**RE: Creekwalk North Development Plan and Plat Projects
AR DP 21-00551 and AR FP 21-00552**

Kimley-Horn and Associates represents the planning and engineering team for Creekwalk North Development Plan and Plat projects (City Numbers: AR DP 21-00551 and AR FP 21-00552). In response to the January 20, 2022 appeal letter submitted to the City, the following responses have been provided.

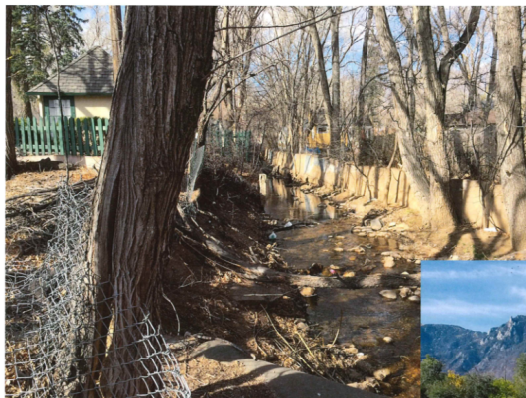
2. The Development Plan and Plat Will Result in Unreasonable Auto Traffic
 - *Response: The development plans for both Creekwalk North and South have actively worked City traffic and CDOT to address traffic access and level of service concerns in the area, improving the current conditions. This includes the addition of a new traffic lane on Cheyenne road, the reduced number of access point along Cheyenne Road and South Nevada Ave, and the study of signalization in the area.*

While not all of the signalization work is completed with the Creekwalk Development Plans, the projects will have made improvements with the signals at Cheyenne road and Roanoke St., and the alignment at

Ramona Ave. The project is also making large improvements in pedestrian facility and access with streetscape improvements along Cheyenne Road and South Nevada Ave and through the extension and development of public access along Cheyenne Creek.

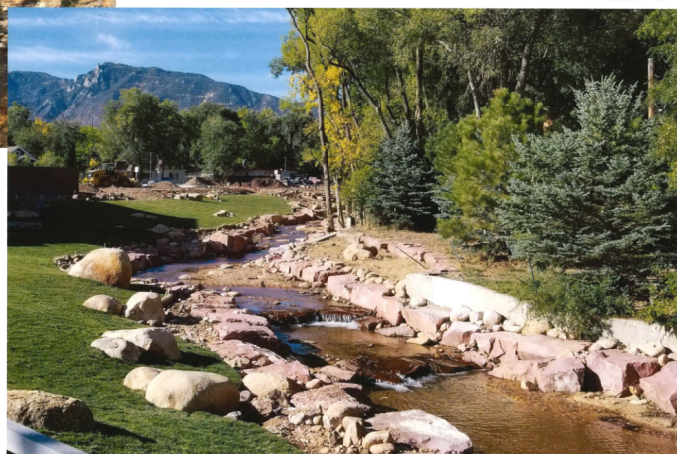
- *The BID funds and maintains the systems base on taxes generated by the project.*
4. Has the five criteria set forth in the Colorado Springs "Policy Clarification" entitled "Criteria for Underground BMPs," dated April 12, 2017, had been met with respect to the proposal.

- *Response: Yes, the systems (North and South) have been designed and will be installed and maintain per the latest criteria within the current Drainage Criteria Manual Volume. This also means that the systems and designs have been reviewed and approved by the City of Colorado Springs and the City of Pueblo as part of the approval process.*

- *The following images capture the successful creek redevelopment work completed to date associated with Creekwalk South:*
